**Park Fuels  
MP07\_0066 MOD 1 & 2  
Section 75W Modifications**

### **2.1 Modification 1 (MP 07\_0066 MOD 1)**

### **2.2 Modification 2 (MP 07\_0066 MOD 2)**

**Figure 3:** The Park Fuels site and surrounding land use on Kooragang Island

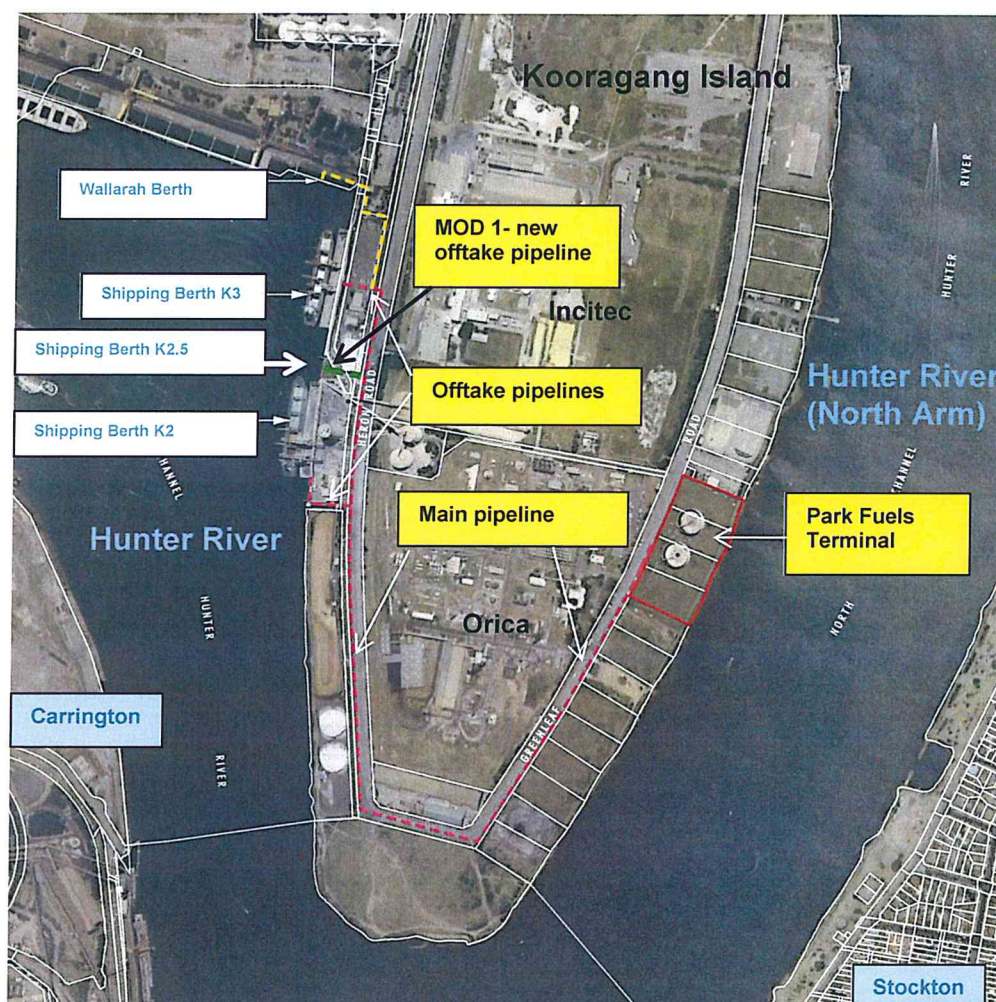
Park Fuels are seeking approval for a new offtake pipe to Berth K2.5 and the slight re-alignment of the previously approved offtake pipe to Berth K2. PANSW had recommended that Park Fuels utilise the new Berth K2.5, as it has been constructed specifically for ships loading or unloading product by pipeline.

The use of an additional offtake pipe will allow Park Fuels to transfer fuel products to and from three shipping Berths (K2, K2.5, and K3), providing greater operational versatility. The dotted line coloured green on **Figure 3** indicates the location of the proposed new offtake pipeline which is proposed to be around 75 metres (m) long and 40 centimetres (cm) in diameter, and:

PoN did not object to either application but, in relation to MOD 1, requested that Park Fuels provide it with detailed design for the new pipeline for approval prior to the commencement

of construction. This requirements has been included with the recommended conditions of approval.

**Figure 4:** Layout of approved Marine Fuel Storage and Biodiesel Production Facility

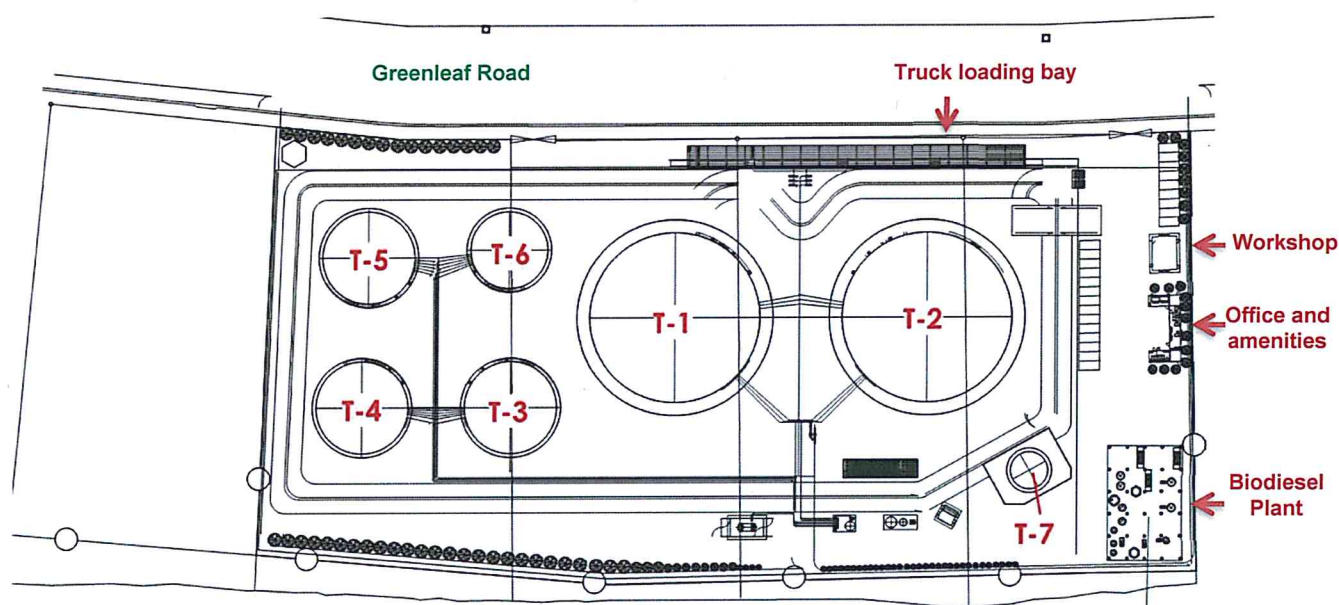
On 21 May 2014, Park Fuels lodged a second modification application (MOD 2) to replace the Internal Floating Roofs (IFR) for Tanks T1, T2 and T7 (refer to **Figure 4**) with standard fixed roofs without the internal floating 'blankets'. These tanks were originally designed with IFR to minimise potential vapour emissions.

In addition to the above changes, T7 would be used for the storage of biodiesel rather than methanol. Park Fuels considers that the removal of methanol storage from the Project significantly reduces the risks involved with the operation of the facility, in particularly the risk of flammable vapour generation.

- normal and emergency venting arrangements for the three tanks which are to have fixed roofs rather than IFR (T1, T2 and T7);
- safety analysis for the hot oil system for T1 (containing heavy fuel oil); and
- updating the Fire Safety Study (FSS) for the modified site.

<b>Change in tank design (MOD 2)</b>	<ul style="list-style-type: none"> <li>• MOD 2 proposes to remove the Internal Floating Roofs (IFRs) from Tanks T1, T2, and T7. The IFRs were integral to the design of these previously approved tanks, and are typically used on tanks storing substances with high vapour emissions such as methanol.</li> <li>• As MOD 2 seeks to remove the storage of methanol (which is flammable and has a higher vapour pressure than combustible liquid fuels such as diesel, fuel oil and biodiesel), Park Fuels considers that it is no longer necessary for tanks T1, T2 and T7 to have IFRs. Park Fuels has stated that IFRs are not mandated by any Australian Standard or American Petroleum Institute Standard (API) for the storage of combustible fuels.</li> <li>• In its submission the EPA agreed that IFRs would no longer be required for Tanks T1, T2 and T7 if methanol is not going to be stored on site.</li> <li>• The Department agrees that the use of IFRs in tanks containing low vapour pressure combustible liquids, such as diesel and biodiesel, is not mandated by any Australian or international standards and has recommended conditions relating to the relevant standards for the storage of combustible liquids.</li> <li>• The EPA recommended that conditions are included to ensure that only combustible liquids with a vapour pressure of &lt;2 Hg at 25°C and 101.3kPa are stored in T1, T2 and T7;</li> <li>• Park Fuels has agreed to design and construct the tanks in accordance with the relevant API standards for tank construction and venting, and to ensure that all stored fuels meet the EPA's requirements.</li> <li>• The Department's assessment concludes that with the recommended conditions, the removal of IFRs from the three tanks would not adversely alter the risk profile for the facility or increase the potential risk for 'escalation' in the unlikely event of a tank top surface fire occurs.</li> </ul>	<p>Recommended conditions require the Proponent to:</p> <ul style="list-style-type: none"> <li>• design and construct tanks T1, T2 and T7 in accordance with <i>API 650: Welded Steel Tanks for Oil Storage</i>;</li> <li>• ensure that vented systems on all tanks comply with <i>API 2000: Venting Atmospheric and Low-pressure Storage Tanks</i>;</li> <li>• comply with the requirements of the current edition of <i>AS1940: The storage and handling of flammable and combustible liquids</i>; and</li> <li>• ensure that only combustible liquids with a vapour pressure of &lt;2 Hg at 25°C and 101.3kPa are stored in Tanks T1, T2, and T7.</li> </ul>
